RE: 107X Lowell Road – CLCT Boardwalk
Notice of Intent Application – NRC & DEP Comments

Concord NRC Comments:

MassDEP Comments:

WETLAND BUFFER IMPACT PLAN
 Sheet Number

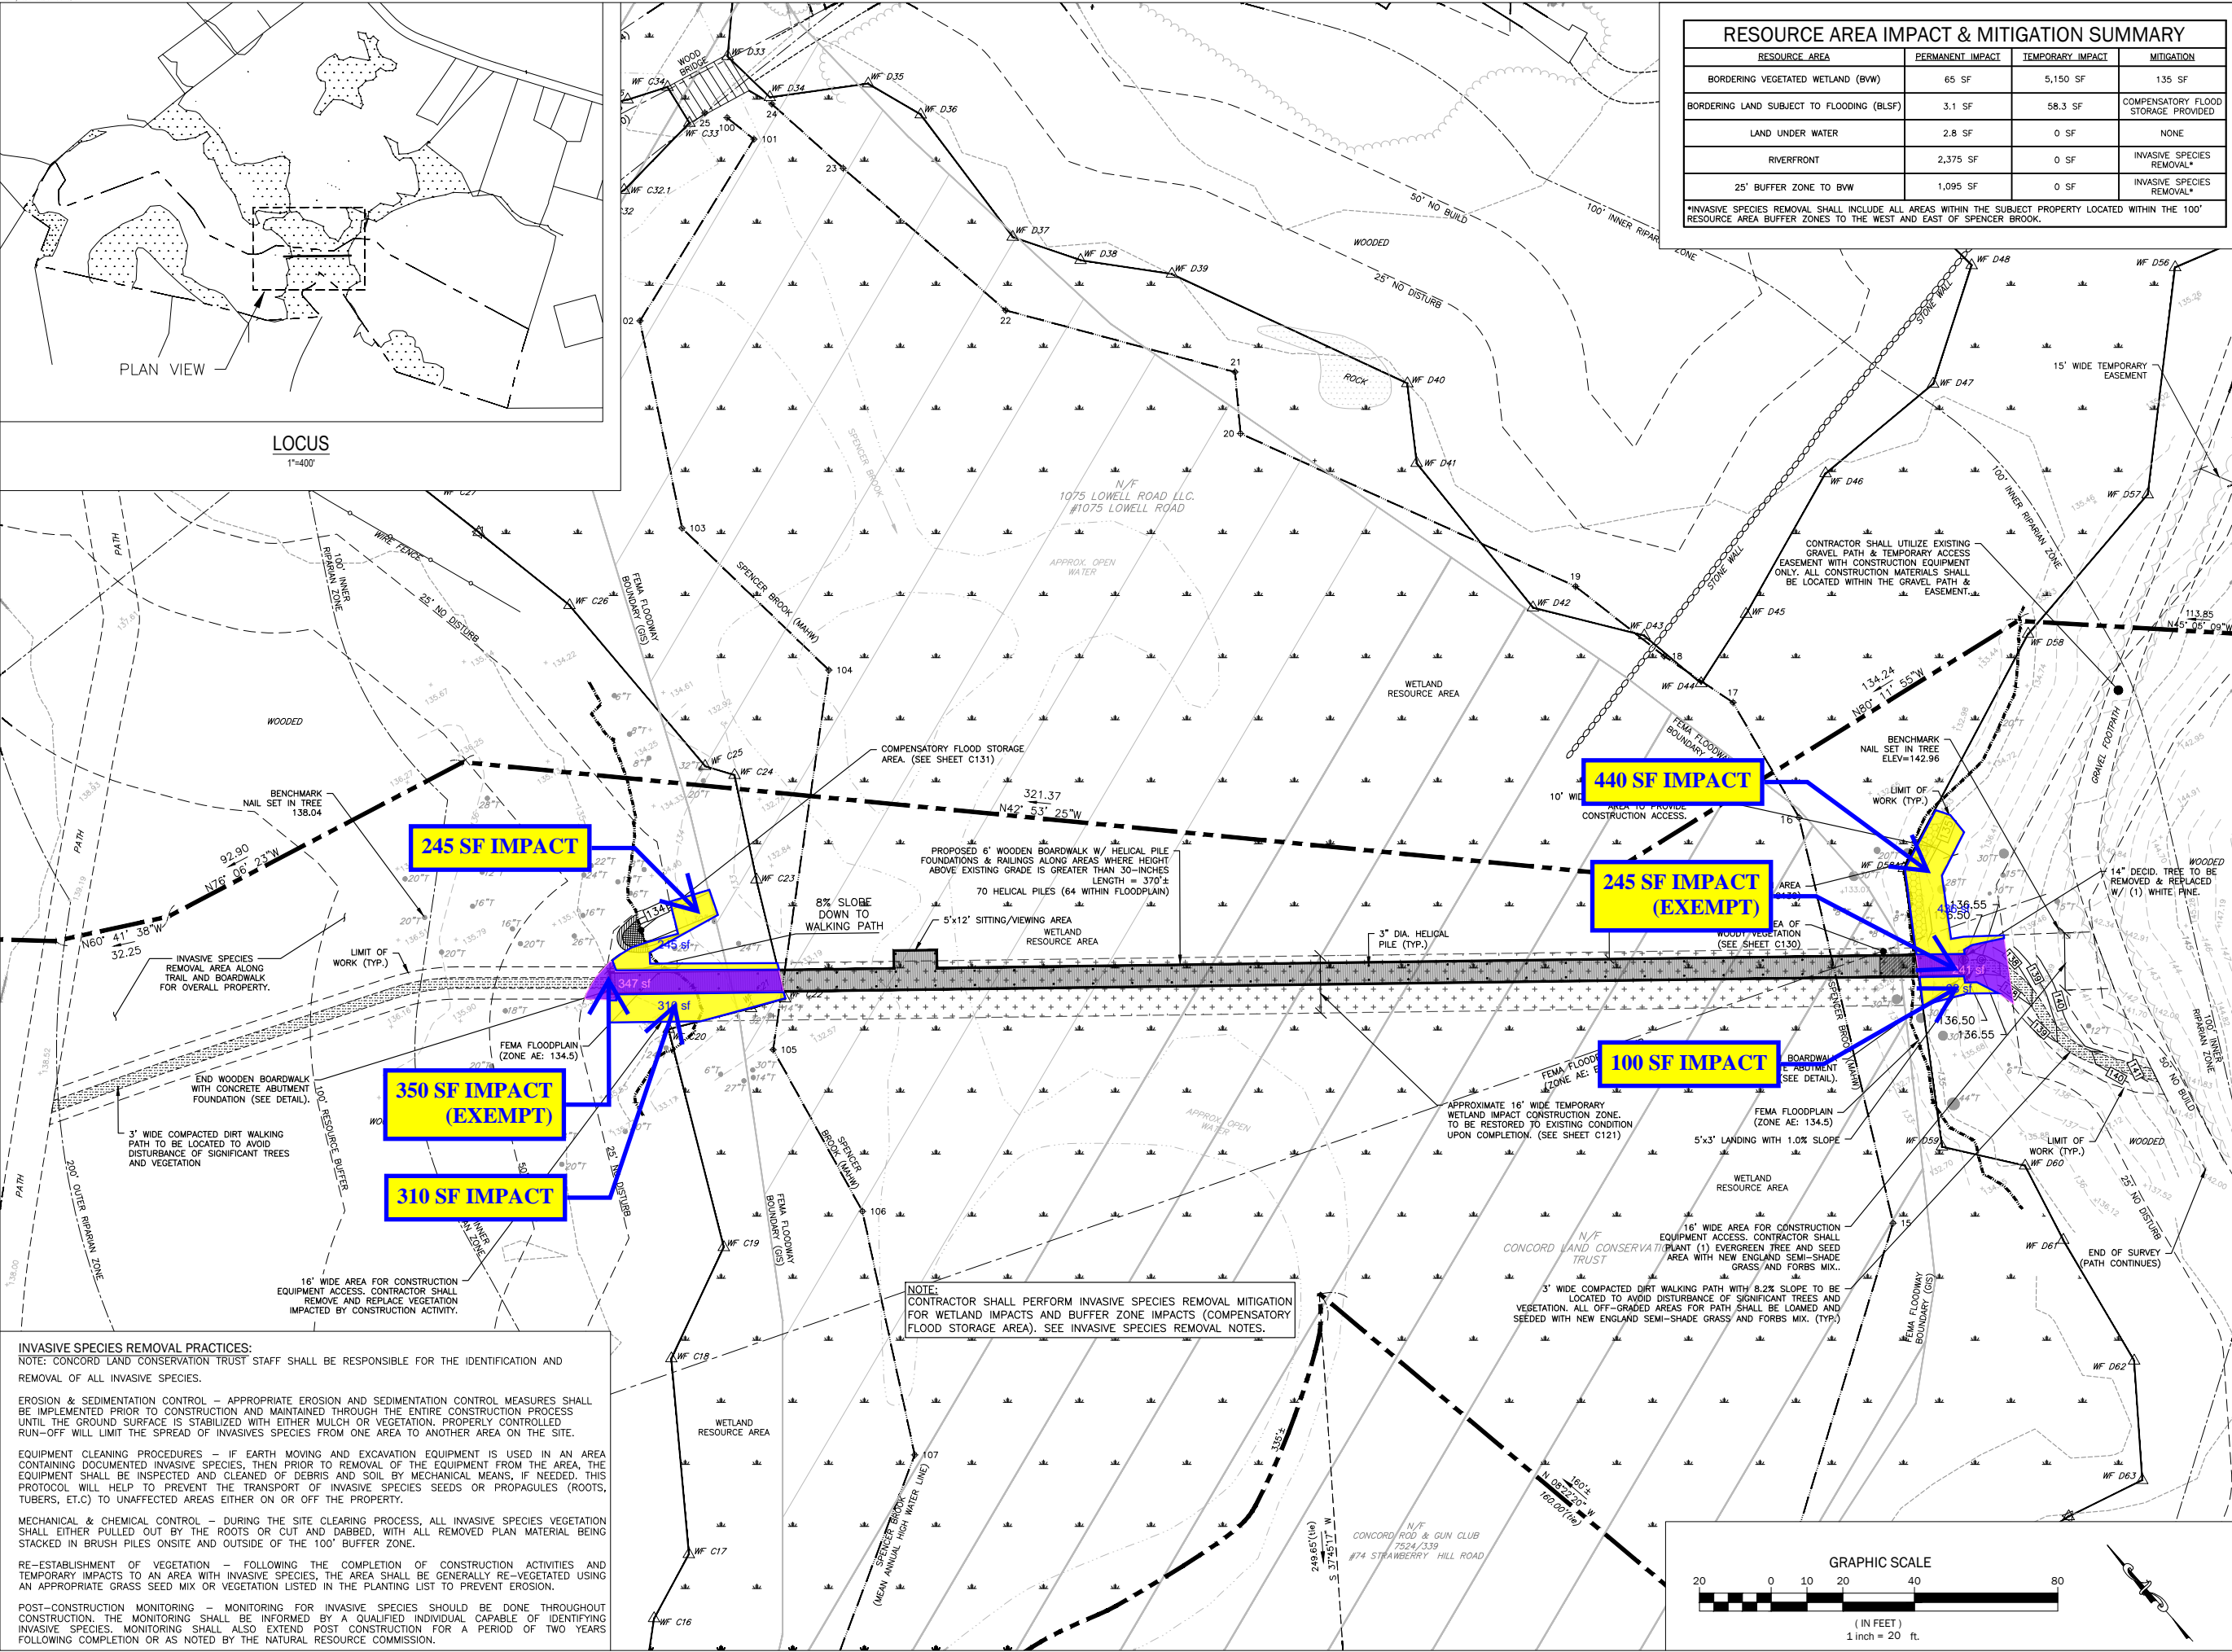
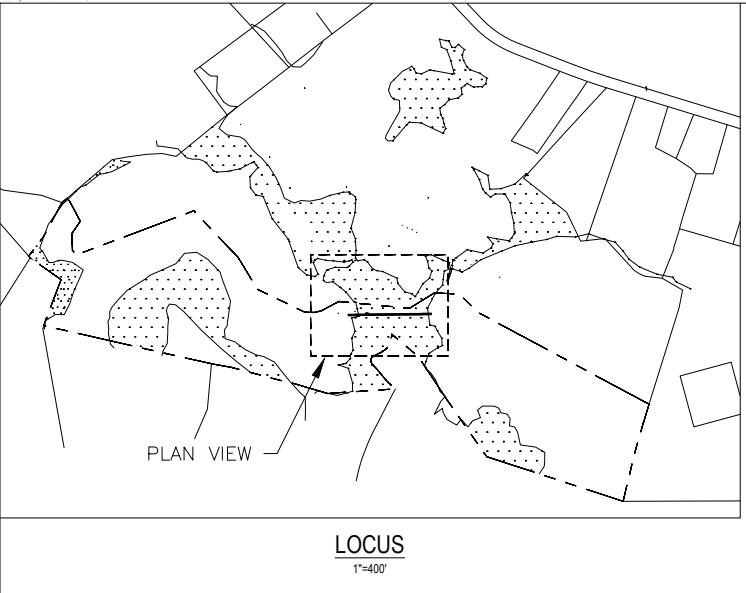
NRC Comment #6: *Please provide a new plan sheet that identifies impacts to all wetland resource areas (BVW, BLSF, Land Under Water, and Riverfront and Buffer Zone). The “exempt impacts” provided in the narrative do not need to be quantified or noted on this plan.*

NRC Comment #12: *Proposed mitigation for wetland resource areas and buffer zone impacts includes invasive species removal within the 25-foot NDZ and BLSF. The WPA regulations require that wetland impacts are mitigated by wetland creation at a 1:1 ratio. RFA/buffer zone impacts can be mitigated through invasive species removal followed by mitigation plantings. Creation of the trail, which appears to be the primary impact in the RFA and Buffer Zone, may not need mitigation.*

Riverfront Area (RFA) / buffer zone impacts have been mitigated through invasive species removal. The plans have been updated to note that the applicant's request to remove invasive species within the entirety of the RFA within their property. Mitigation plantings in the form of shrubs and trees have not been proposed with the exception of the proposed shrub plantings in the wetland replication area. The property is densely vegetated and mitigation plantings for invasive species removal would not be appropriate with these site conditions.

RESOURCE AREA IMPACT & MITIGATION SUMMARY			
RESOURCE AREA	PERMANENT IMPACT	TEMPORARY IMPACT	MITIGATION
BORDERING VEGETATED WETLAND (BVW)	65 SF	5,150 SF	135 SF
BORDERING LAND SUBJECT TO FLOODING (BLSF)	3.1 SF	58.3 SF	COMPENSATORY FLOOD STORAGE PROVIDED
LAND UNDER WATER	2.8 SF	0 SF	NONE
RIVERFRONT	2,375 SF	0 SF	INVASIVE SPECIES REMOVAL*
25' BUFFER ZONE TO BVW	1,095 SF	0 SF	INVASIVE SPECIES REMOVAL*
